**UNITED STATES
NUCLEAR REGULATORY COMMISSION**

SUBJECT: CLINTON POWER STATION - FINAL SIGNIFICANCE DETERMINATION OF A WHITE FINDING WITH ASSESSMENT FOLLOW-UP AND NOTICE OF VIOLATION; NRC INSPECTION REPORT NO. 05000461/2018092

Final Significance Determination

Figure 1: Loss of Offsite Power (LOOP) Event Tree

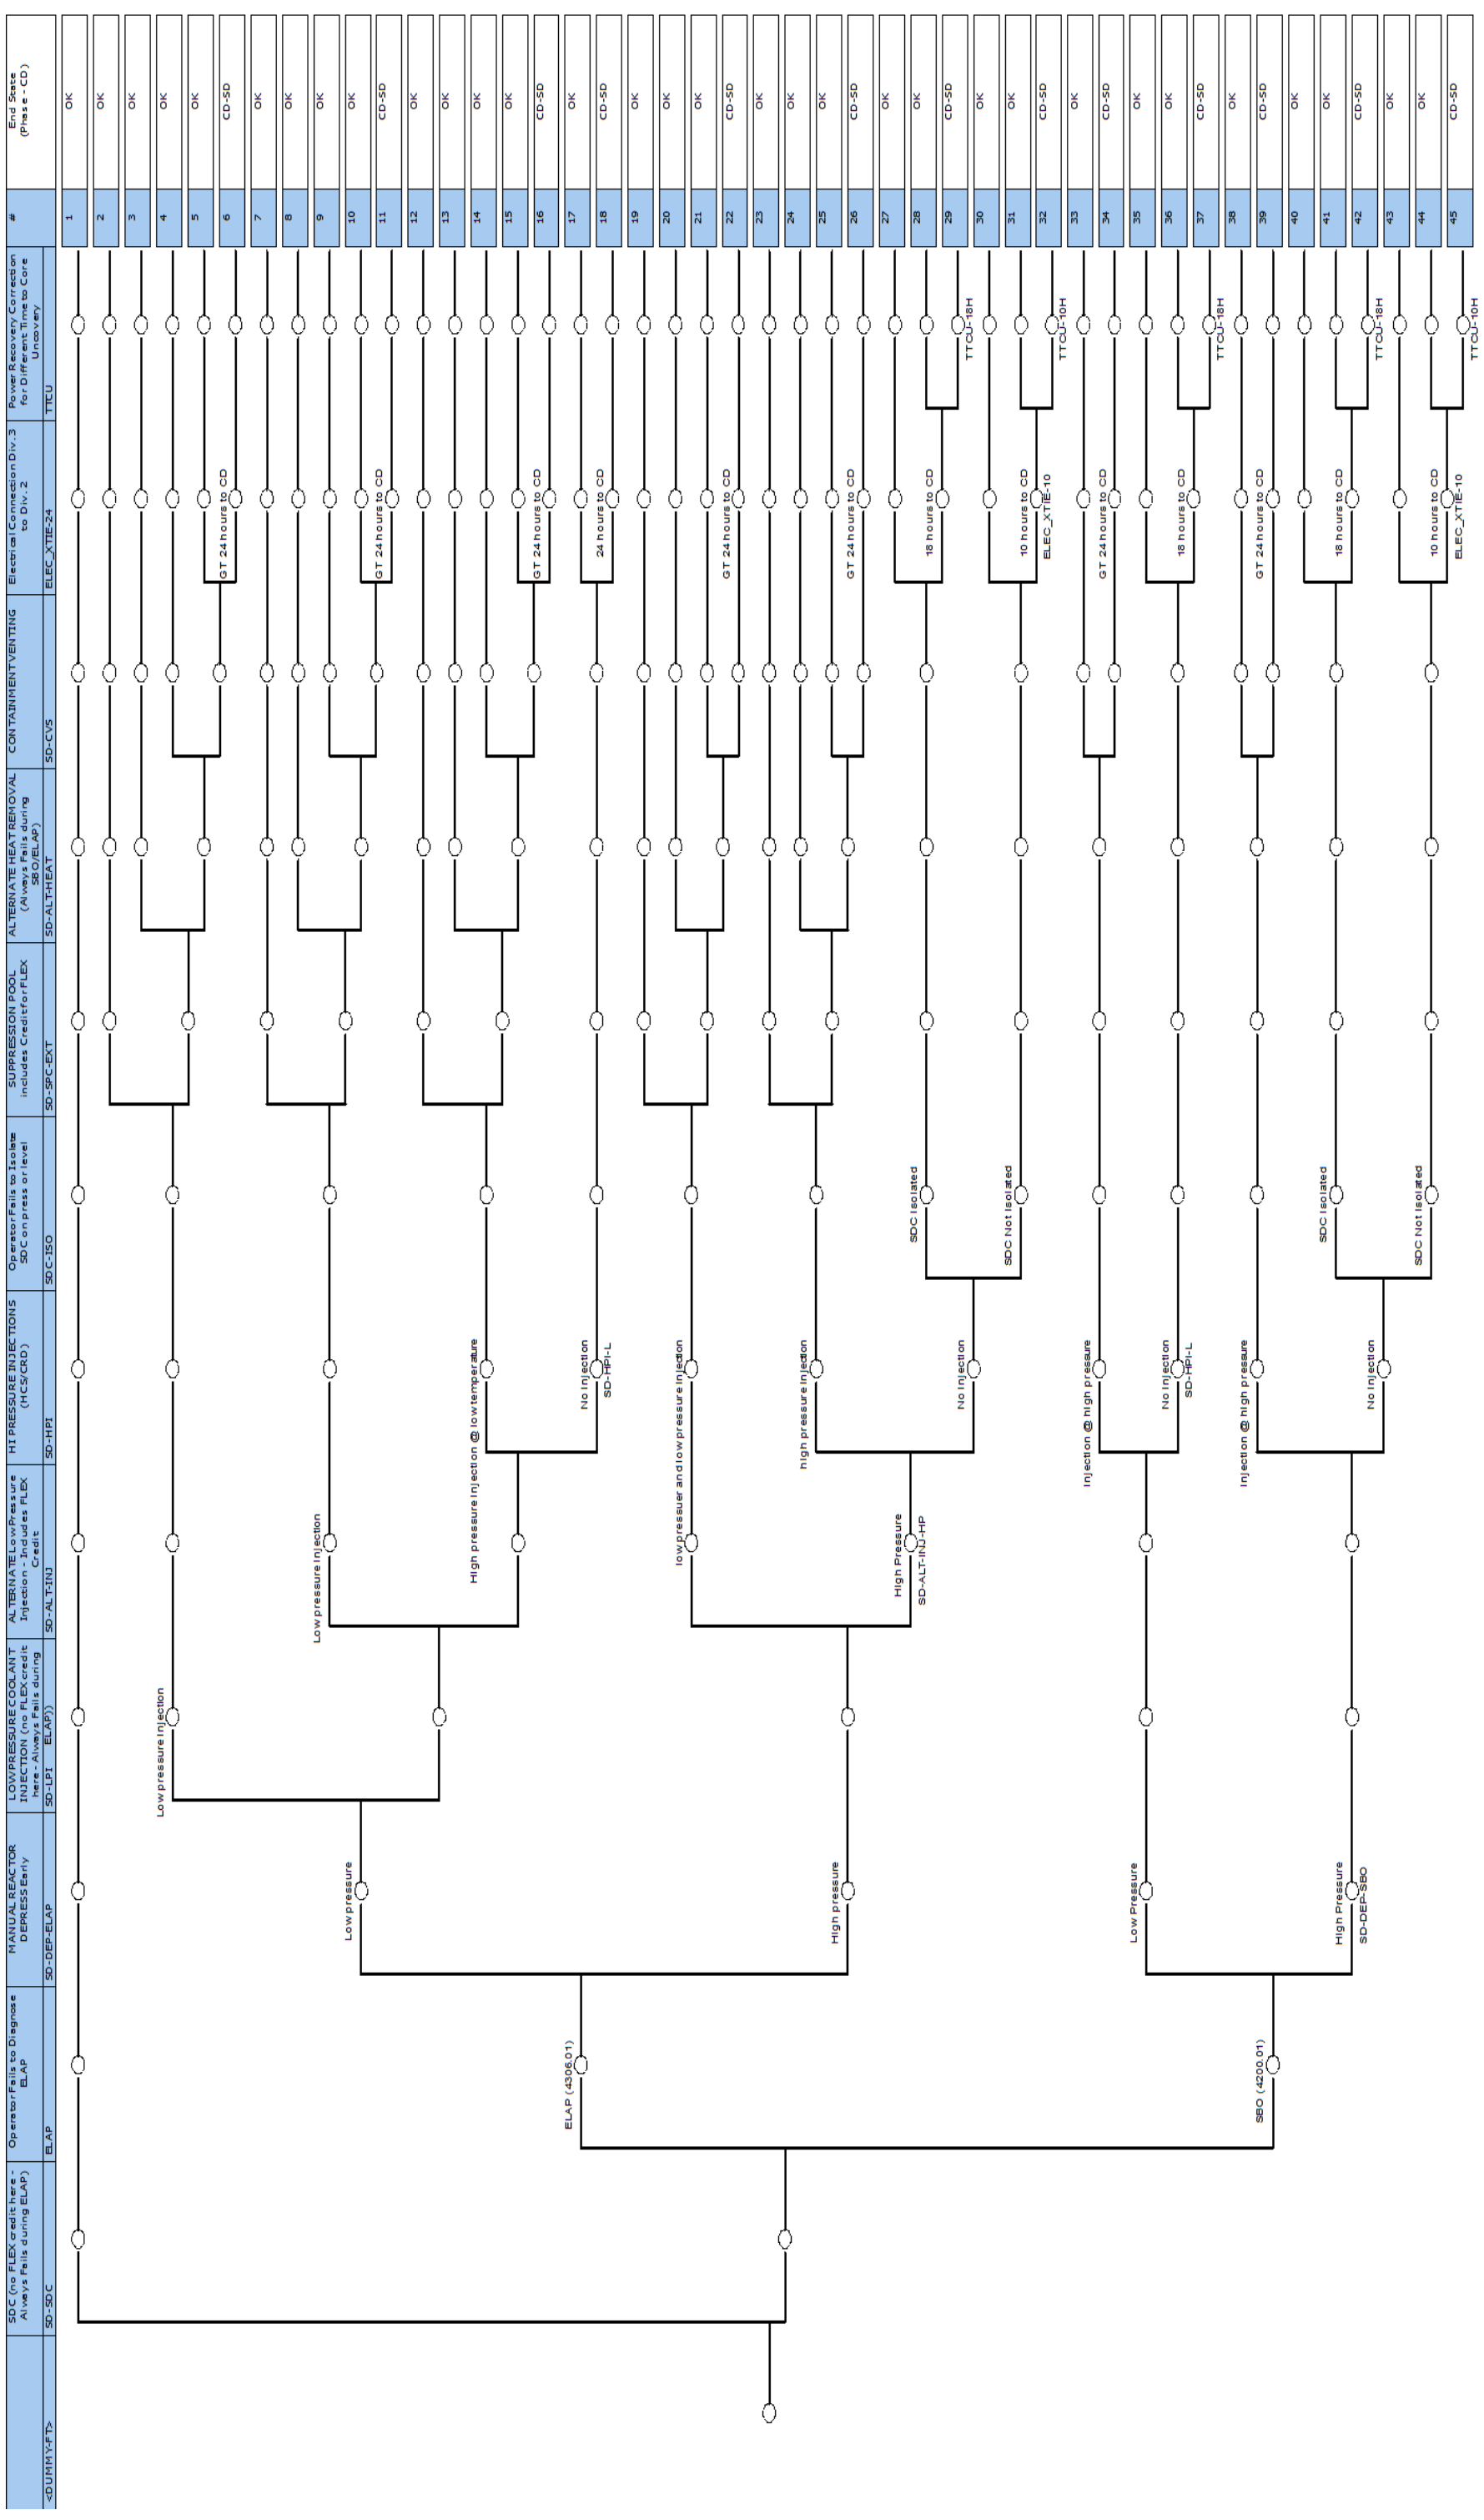
The new information led to changes to the event tree (ET) structure used to quantify the risk. This ET is shown in Figure 1 below. The top two dominant core damage sequences were Sequences 18 and 37. Sequence 18 includes: LOOP initiates, failure of the emergency diesel generators (EDG), failure to recover either of the two EDGs and offsite power, successful ELAP diagnosis, successful early reactor depressurization, failure of low pressure injection (including FLEX), failure of high pressure injection, and failure of the Division 3 to Division 2 cross-tie. Sequence 37 includes: LOOP initiates, failure of the EDG, failure to recover either of the two EDGs and offsite power, failure to diagnose ELAP, successful early reactor depressurization, failure of high pressure injection, failure to perform the cross-tie.

Based on the above understanding, the NRC concluded that its PRA modeling approach to declaring ELAP is reasonable and realistic. However, the NRC's PRA model was modified to test the assumption that operators declare an ELAP or remain in the station blackout procedure. The modified ET is shown in Figure 1. A new top event was added to the model as a decision point. If the decision is made to declare ELAP and enter the FLEX procedures, then the FLEX strategies are then tested. If the FLEX strategies fail, then the cross-tie is questioned.

To incorporate this new information, the NRC modified its risk analysis by adding a new event tree (ET) top event that tested for failure to isolate the RHR/SDC system from the RCS on high reactor pressure and decreasing reactor level. The modified ET is shown in Figure 1. This top event was evaluated using a new fault tree (FT). The FT tests for all three cues discussed above.

The event tree (see Figure 1) tests for successful depressurization. If depressurization is successful, then time to core uncover is extended allowing additional time for subsequent mitigation actions.
